Preferred infrastructure report

WestConnex

## D Preferred infrastructure report

Figure D2-1 Indicative layout for the White Bay civil site (C11)

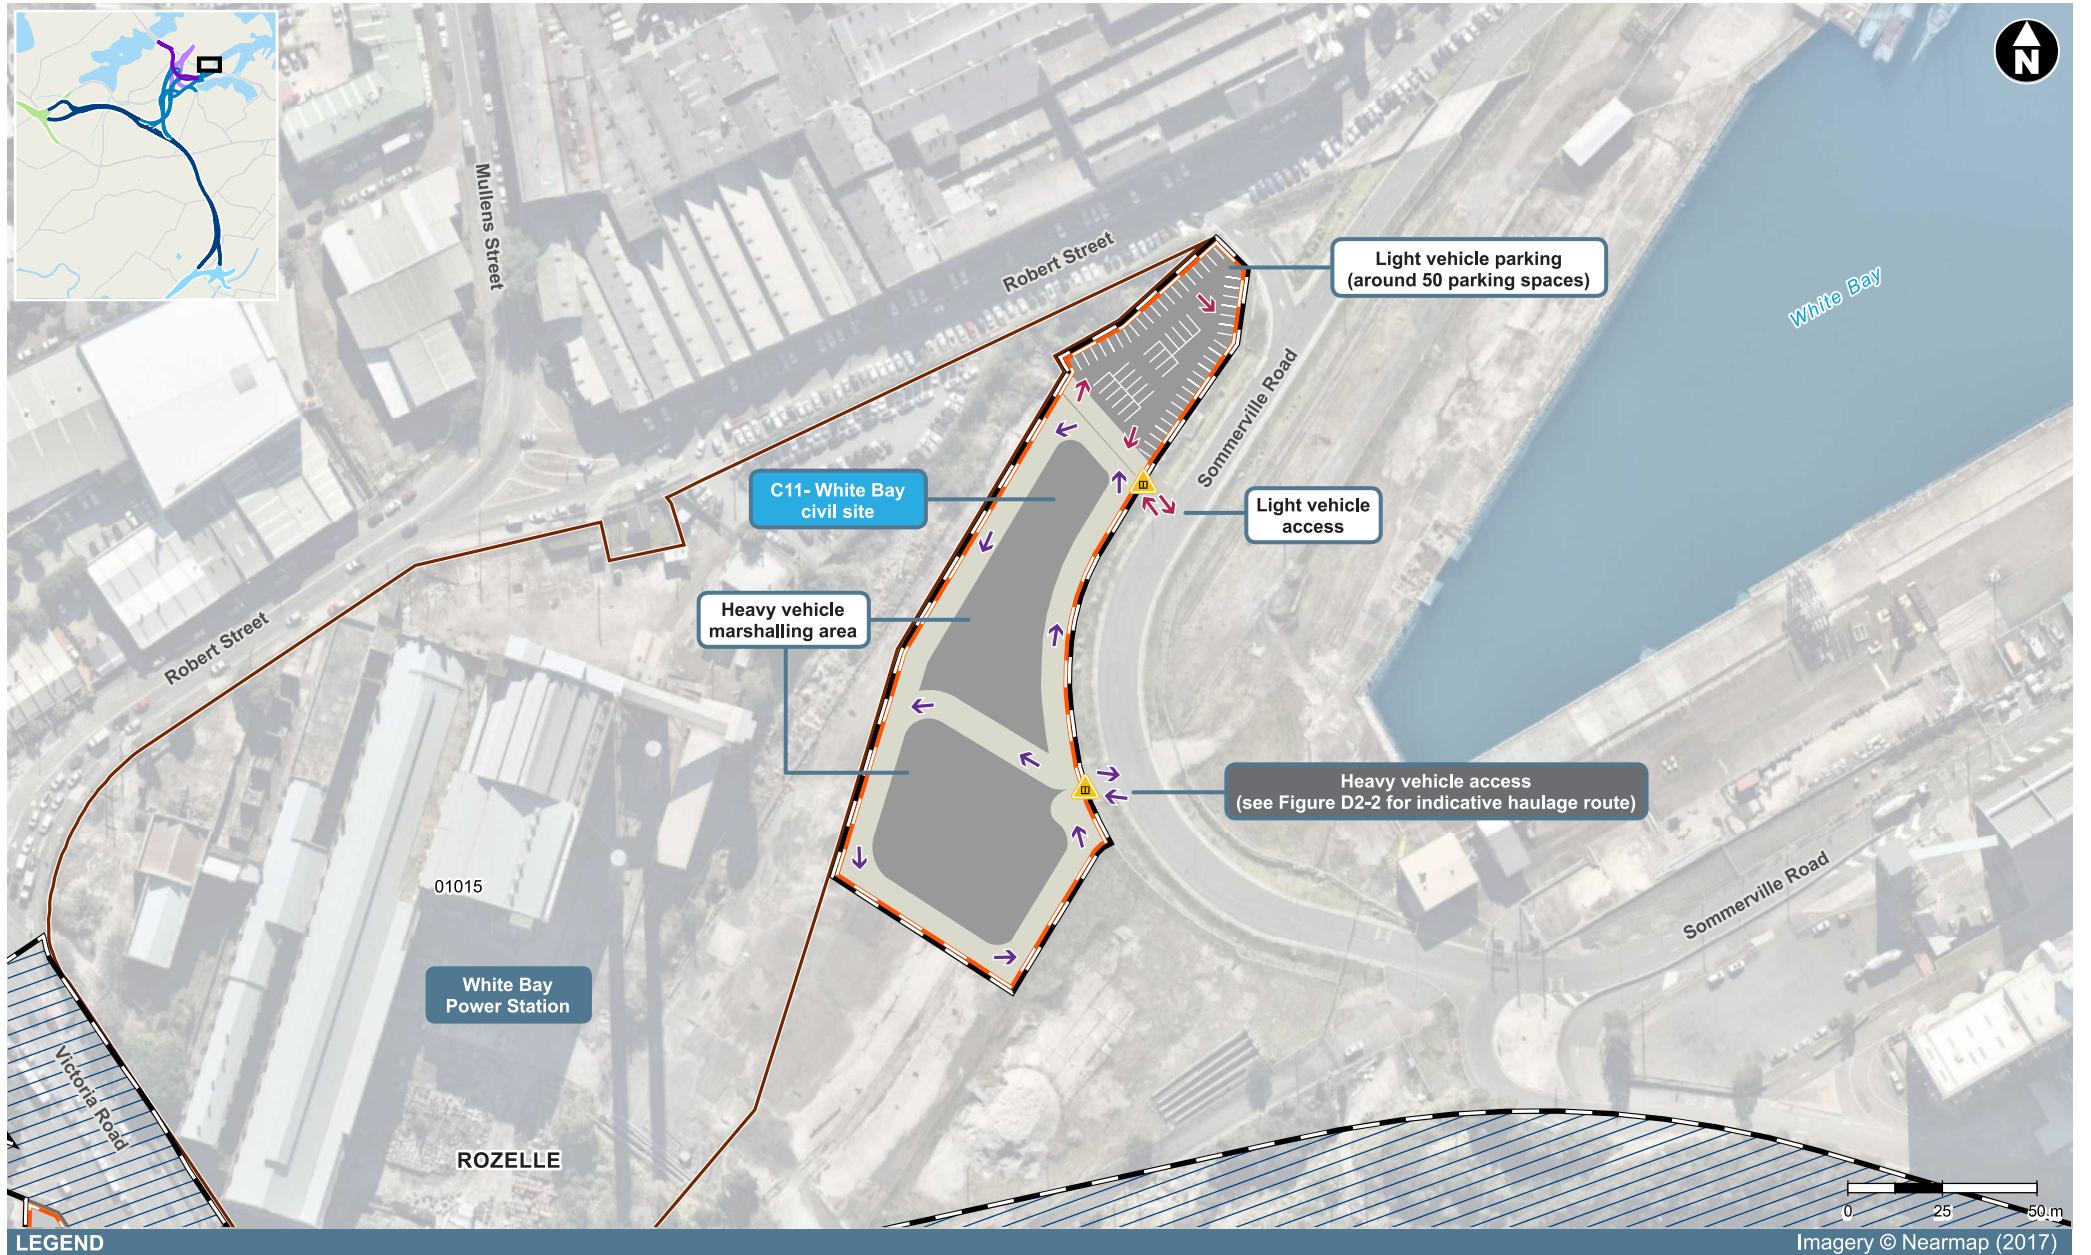
An additional construction ancillary facility is proposed on a portion of the Port Authority of NSW's land located near White Bay at Rozelle. The facility, referred to as the White Bay civil site, would provide a truck marshalling area for around 40 heavy vehicles transporting tunnel spoil and around 50 parking spaces for the project's construction workforce. The facility would also provide additional space to store construction plant, machinery and materials at the site. The location and an indicative site layout are shown in **Figure D2-1**.

The indicative layout of the site includes the northern portion being used for light vehicle construction workforce parking, temporary storage of plant equipment that would be used at other construction ancillary facilities (eg a roadheader that is being moved from one tunnel section to another may use this site as a holding area), a gatehouse and office and amenity buildings. The southern portion is proposed to be used for parking and marshalling for heavy vehicles. This layout has been proposed to ensure that the noisiest use (area for heavy vehicles) is furthest away from the residential and commercial receivers to the north of the site. Vehicle maintenance or refuelling activities would not be carried out at the site.

Figure D3-1 Revised location for the bioretention facility at Rozelle near the Iron Cove Bridge

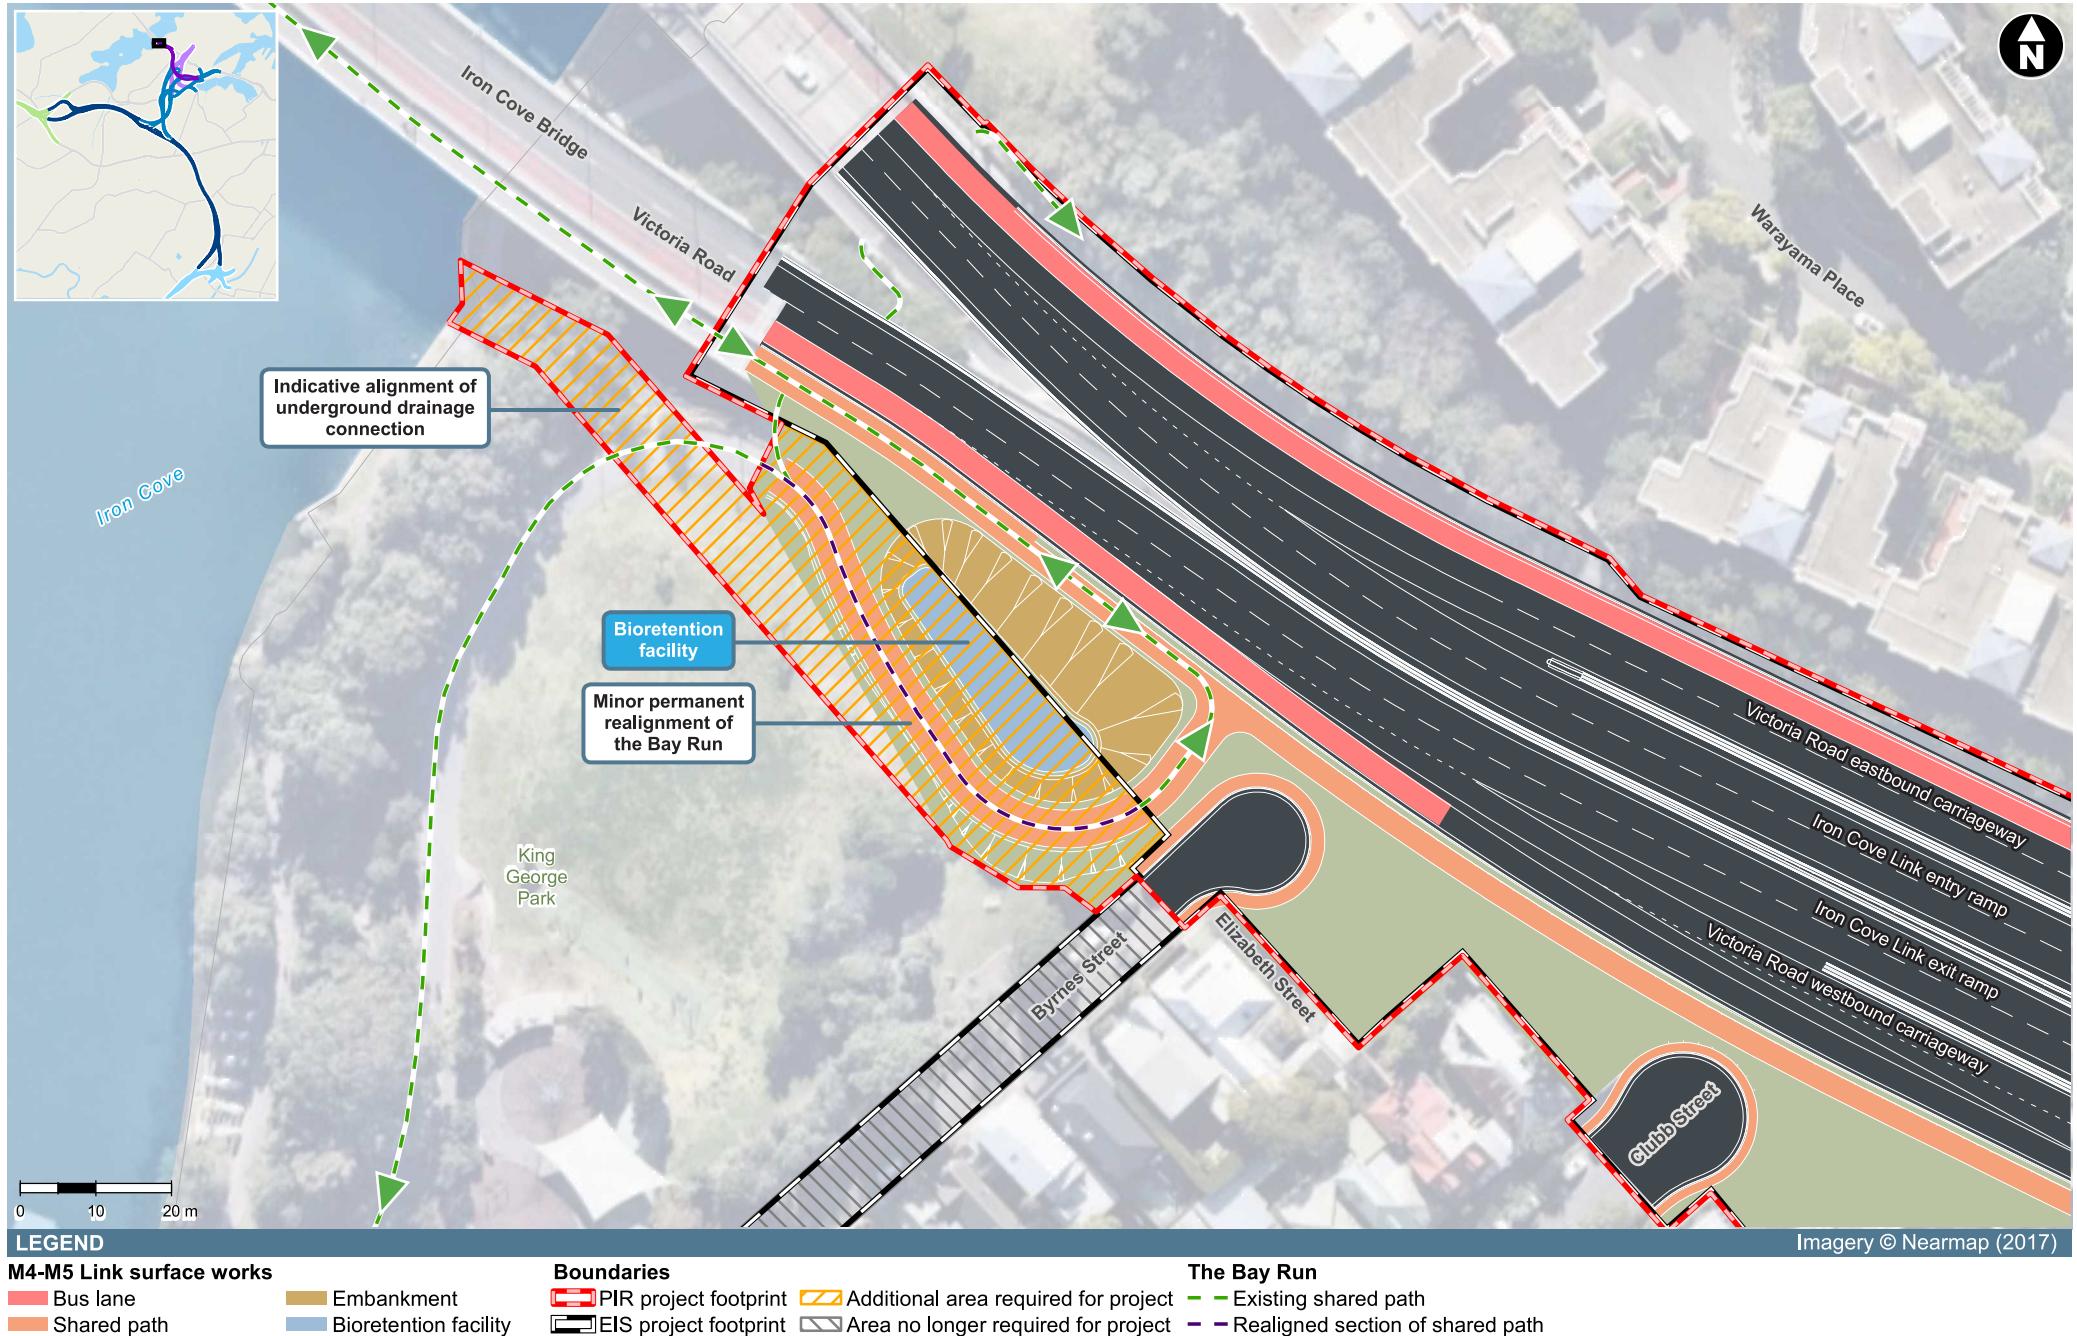
For the reasons stated above, it is proposed to relocate the bioretention facility around 150 metres north of the location presented in the EIS, to an area adjacent to Victoria Road at the eastern abutment of Iron Cove Bridge and within King George Park, as shown in **Figure D3-1**. Part of the land that would be occupied by the bioretention facility at this location is partially outside the project footprint assessed in the EIS. A photo of the new proposed location is provided in **Figure D3-2**. An indicative cross-section of the bioretention facility is shown in **Figure D3-3**.

As a result of relocating the bioretention facility, the existing informal car park at Manning Street would remain in its current condition and would not be altered by the project. The drainage works proposed in the EIS along Byrnes Street for the bioretention facility previously proposed adjacent to Manning Street would no longer be required (see **Figure D3-1**).
